# Access Compliance Report

## Public Rights-of-Way

### (Curb Ramps)

Intersection ID: 47849	Main Street: SERAPE_RD	Cross Street: STONE_PORCH_RD	Location: NW
ADA ID: A7F7ECCB26A3	Ramp Type: PerpDiag	Initial Pass/Fail: Fail	Overall Compliance: No
Severity Score: 8.75			
Codes/Mitigation Info/Possible Solution		Field Measurements/Component Compliance

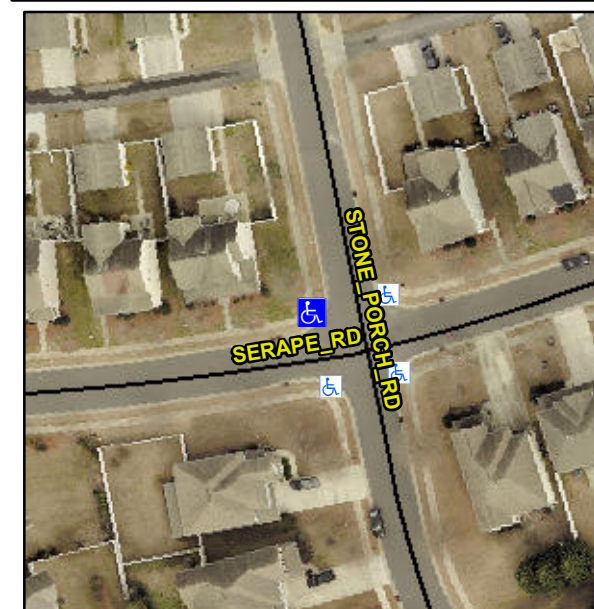
**Not Found, R304.5.1**

Compliance	Description	Data	Compliance	Description	Data
N/A	Ramp Length (in)	52.0	Yes	Ramp Slope (%)	5.1
No	Ramp Width (in)	44.0	Yes	Ramp XSlope (%)	0.2
N/A	Flare Type LT	N/A	N/A	Flare Type RT	N/A
N/A	Flare Slope LT (%)	N/A	N/A	Flare Slope RT (%)	N/A
N/A	Flare Traversable LT?	N/A	N/A	Flare Traversable RT?	N/A
N/A	Landing Length (in)	N/A	N/A	DWS Provided?	N/A
N/A	Landing Width (in)	N/A	N/A	DWS Contrast?	N/A
N/A	Landing Slope (%)	N/A	N/A	DWS Length (in)	N/A
N/A	Landing X Slope (%)	N/A	N/A	DWS Full Width?	N/A
N/A	Landing Curb? (Y/N)	N/A	N/A	DWS Offset (in)	N/A
N/A	Shared Landing?	N/A			
N/A	Gutter Ponding?	N/A	N/A	Gutter Slope (%)	N/A
N/A	Gutter Lip Ht (in)	N/A	N/A	Gutter X Slope (%)	N/A
N/A	Painted X Walk1?	No	N/A	Painted X Walk2?	No
	X Walk 1 Direction	To S		X Walk 2 Direction	To E
N/A	X Walk 1 Width (in)	N/A	N/A	X Walk 2 Width (in)	N/A
	X Walk 1 Slope (%)	1.8		X Walk 2 Slope (%)	0.2
	X Walk 1 X Slope (%)	0.2		X Walk 2 X Slope (%)	1.7

**Remove & Replace Curb Ramp With Two New Directional Ramps or Equivalent.**
